AS BUILT

333 RANCHO
LAS VEGAS
NEL POWERS
INVESTMENT BUILDER
NEVADA

PROJECT NUMBER
79-24
DATE
5-1-80

SHEET
G54-2
OF 13

SECTION

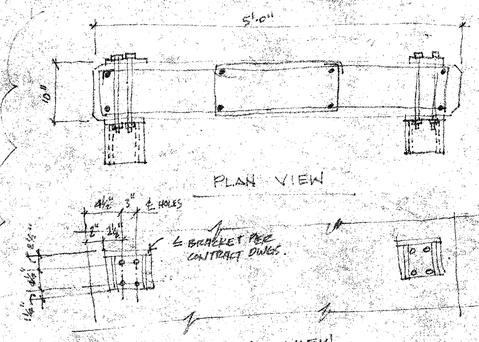
REMEDIAL ACTION REQ'D FOR MISSING 12x12 PL'S @ 4TH WALL COLUMN NORTH OF GRID "C", TOP FLOOR.

REMEDIAL REPAIRS DUE TO DEFECTIVE PL'S

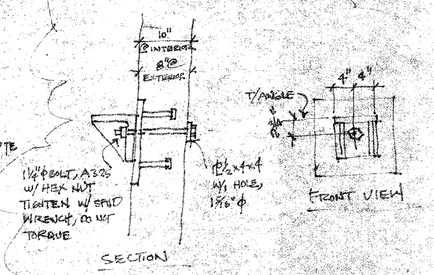
NOTE: WHERE CAST-IN PL'S ARE FOUND TO BE DEFECTIVE BY ULTRASONIC TESTING THE ABOVE DETAIL SHALL APPLY. DRILL HOLES FOR BOLTS 1⅛" OVERSIZE, MAX., BOLTS SHALL BE 1'-4" LG @ 10" PANEL, 11" @ 8" PANEL.
